HOPE CREEK GENERATING STATION
DOCKET NO. 50-354
DRAFT SAFETY EVALUATION REPORT
OPEN ITEM STATUS

Enclosed for your review and approval (see Attachment 4) are the resolutions to the Draft SER open items, NRC questions and structural audit items listed in Attachment 3.

Public Service Electric and Gas Company hereby submits the enclosed responses to DSER open items, NRC Questions, Structural Audit items, and NRC requests for additional information for the Hope Creek Generating Station.

FIGURE 3
LOAD/SETTLEMENT PLOT FOR MARKER NO. 16

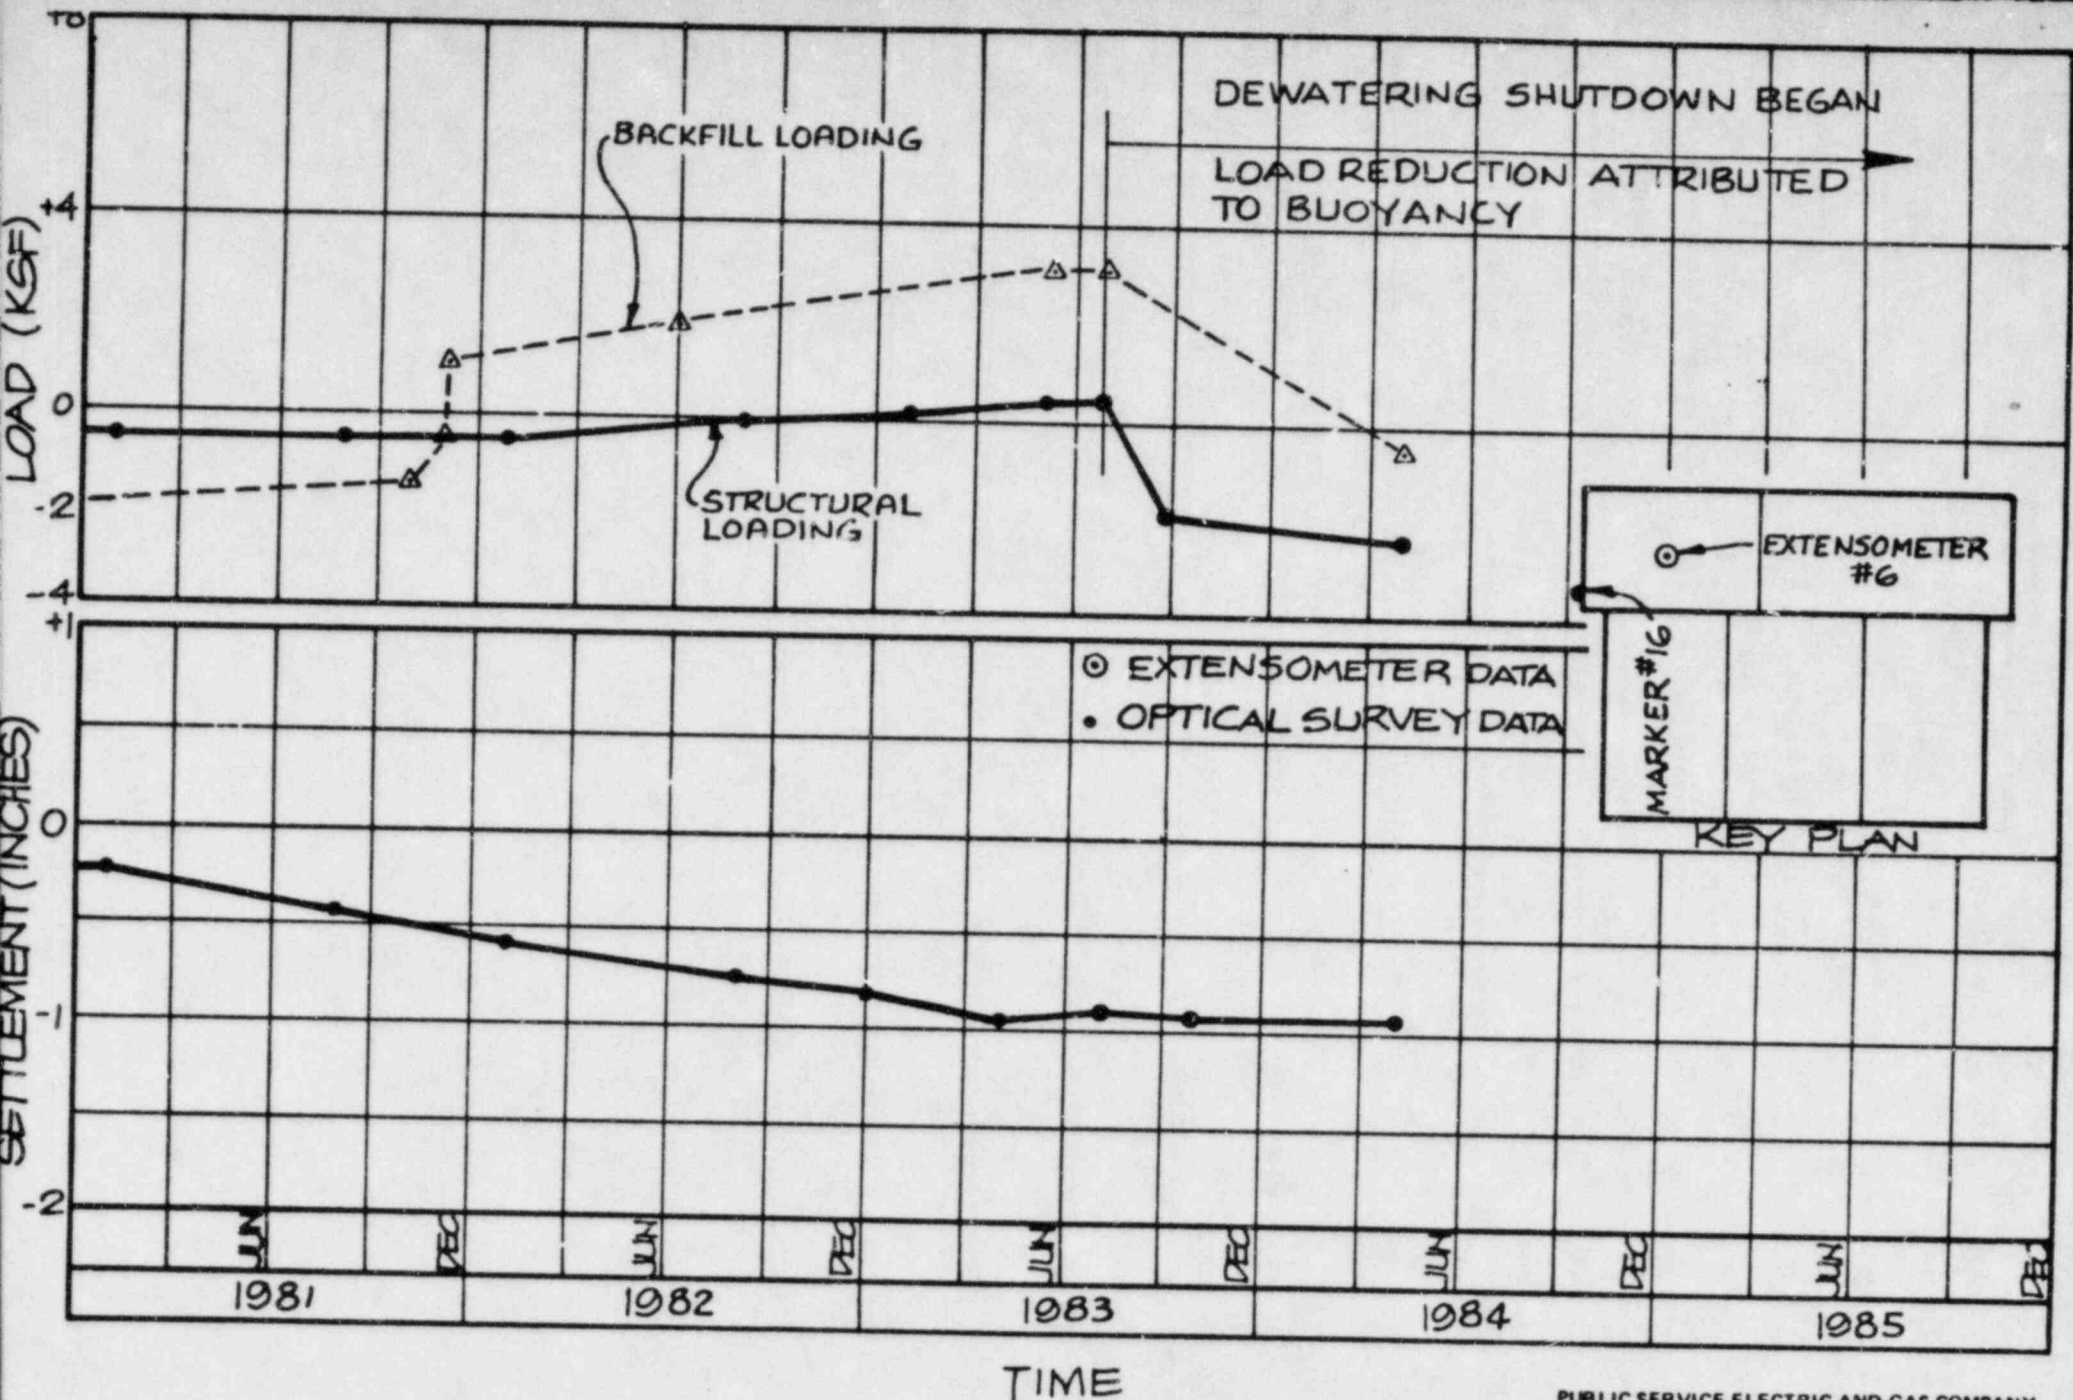
In justification of the statement ^{are} that the settlements measured at marker Nos. 16, 18 and 19, ~~and~~ due to the surrounding backfill loads, given in response to FSAR Question No. 241.25, revise the settlement plots for marker Nos. 3, 5, 16 and 18, as follows:

- o Add the loading history due to backfilling operation
- o Show the effect of decommissioning the dewatering system

The load/settlement plots for markers Nos. 3, 5, 16 and 18, have been revised to include effects of the backfilling and decommissioning of the dewatering system. The revised plots are attached in Figures 1 to 4.

FIGURE 1: 200' Simplified SSI Model Used for Soil Depth Studies for Intake Structure

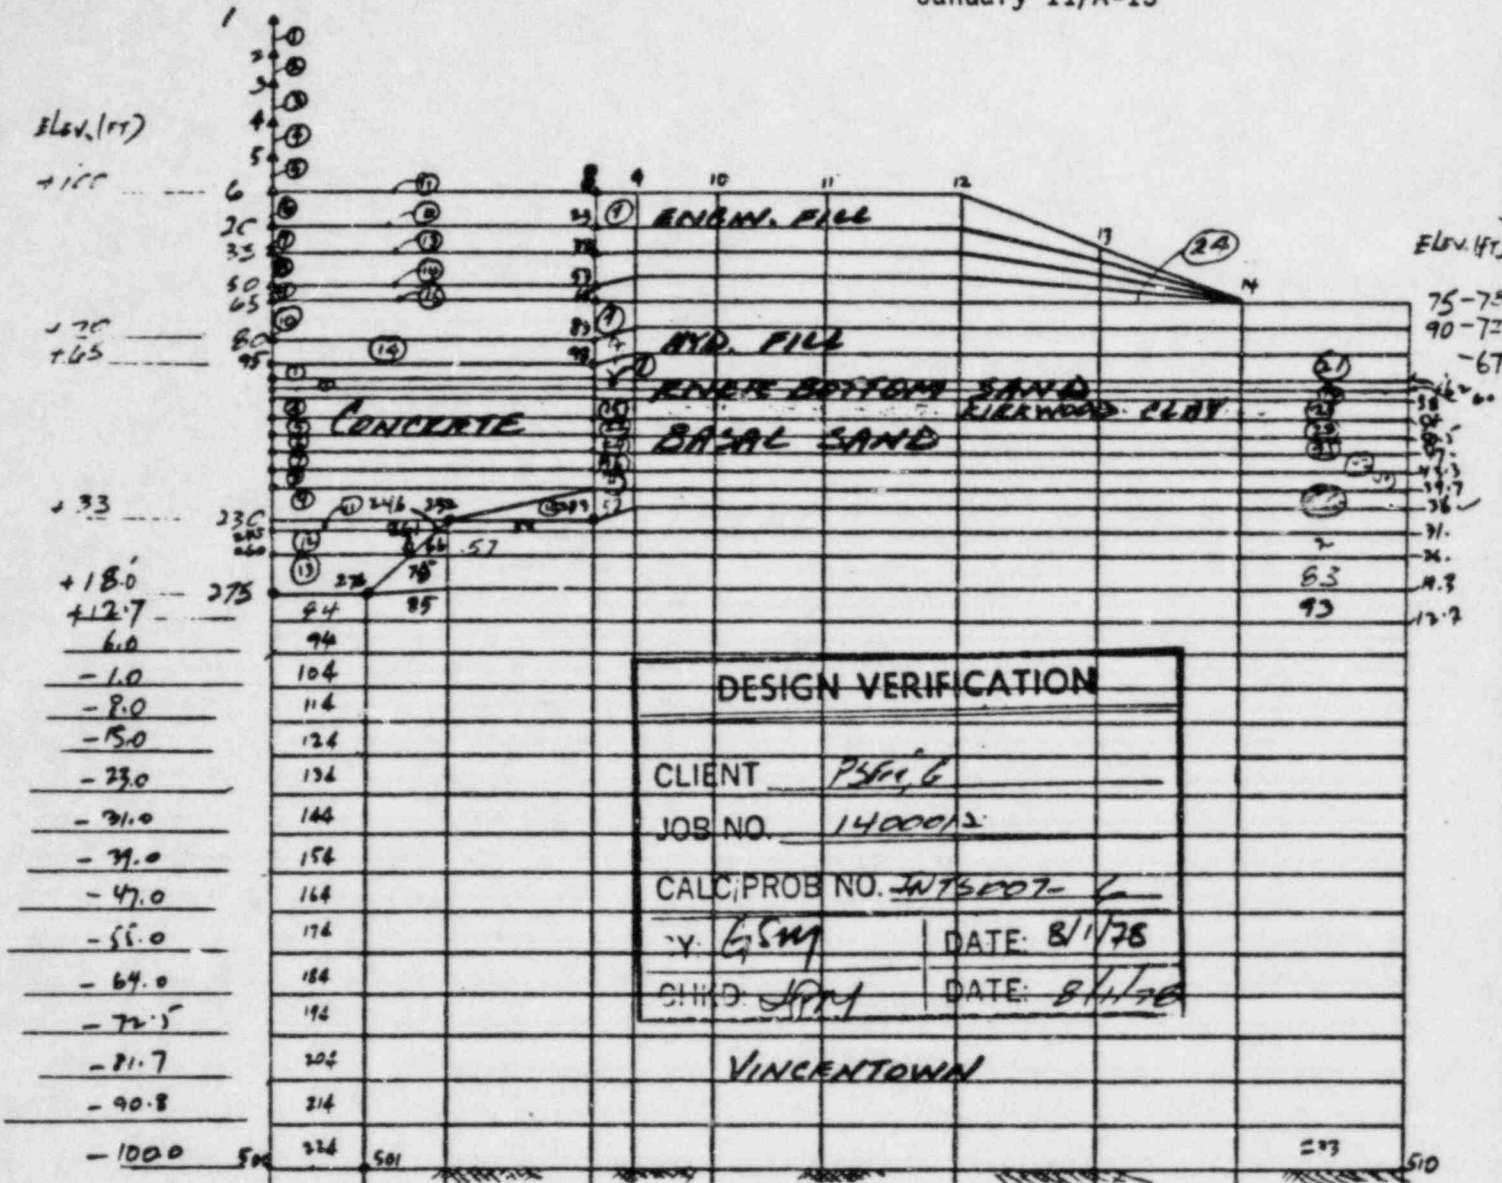
Provide similar plots from the three simplified models which were developed for the Intake Structure Soil Depth study.

RESPONSE: Three models were used for soil depth study of the Intake Structure. These were 200', 300', and 400' simplified soil and structure models. These are shown in Figures 1, 2, and 3; respectively. Deconvolution followed by interaction analyses were performed for each of the three models. The results of these analyses were used to determine the significant depth of interaction.

FIGURE 5: Intake Structure Detailed SSI Model
 Comparison of Peak Shear Strain Versus Depth,
 Suggested Soil Properties

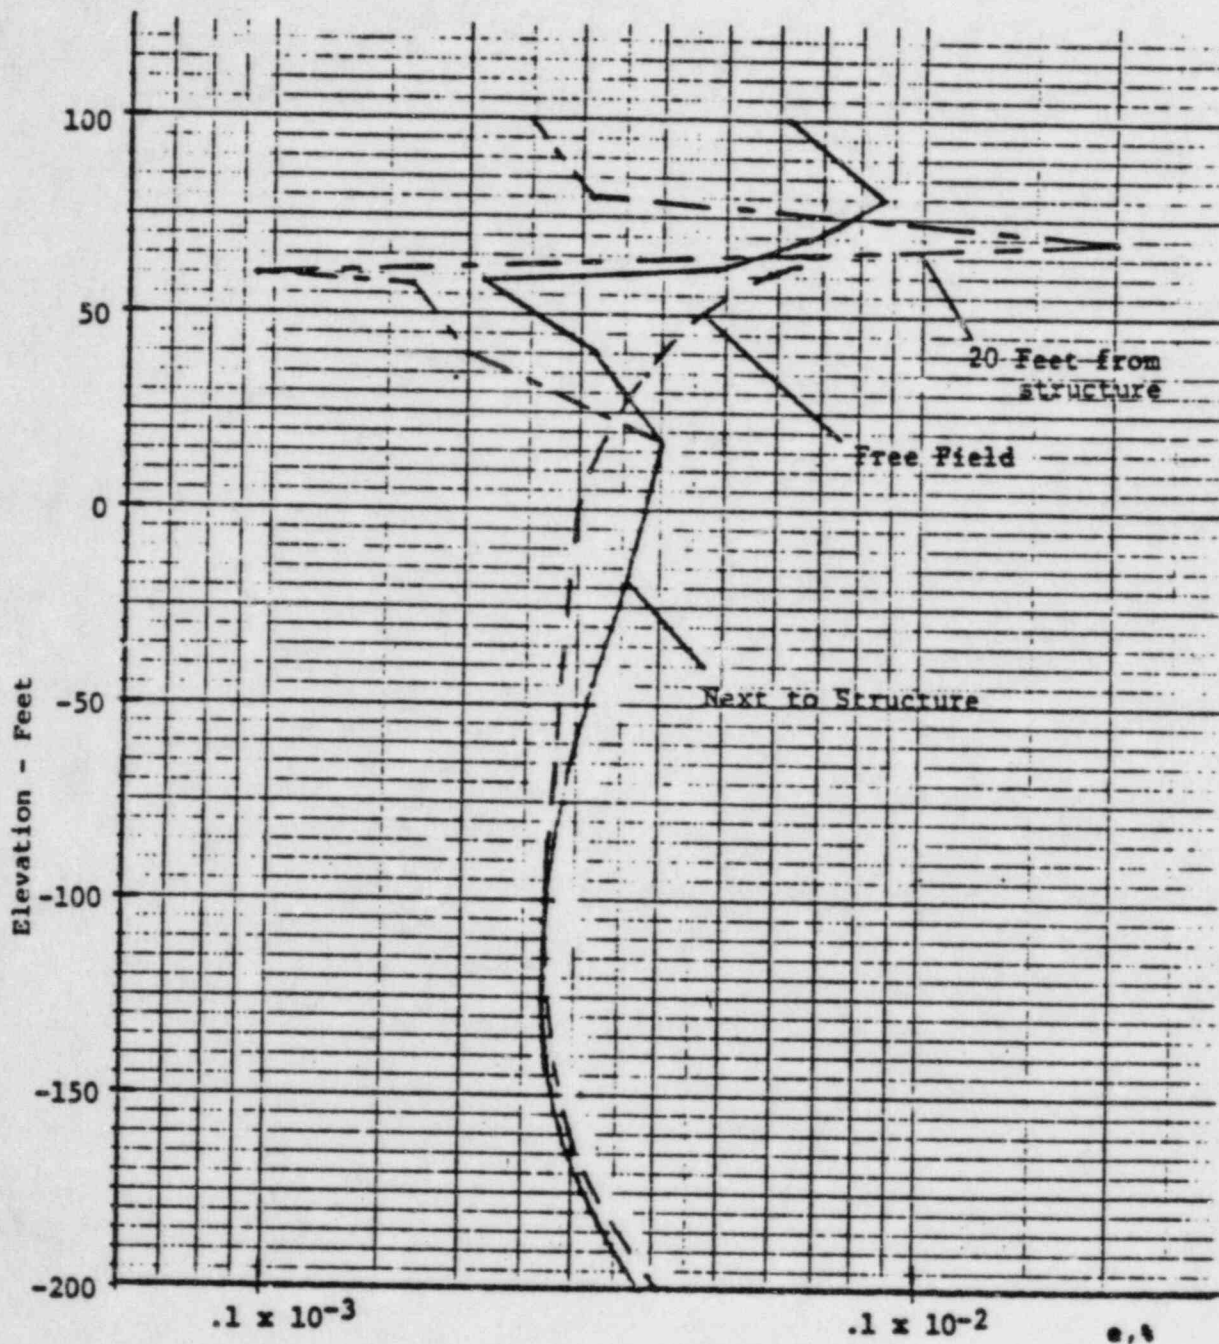
QUESTION: Provide results of three soil depth models for Intake Structure.

To substantiate this conclusion, a similar plot from the detailed SSI model was developed and included in the original response. This plot is attached as Figure 5 to this response. This figure also indicates that strains converge at an elevation of -100 feet, indicating that this elevation limits the depth of significant interaction for the Intake Structure.
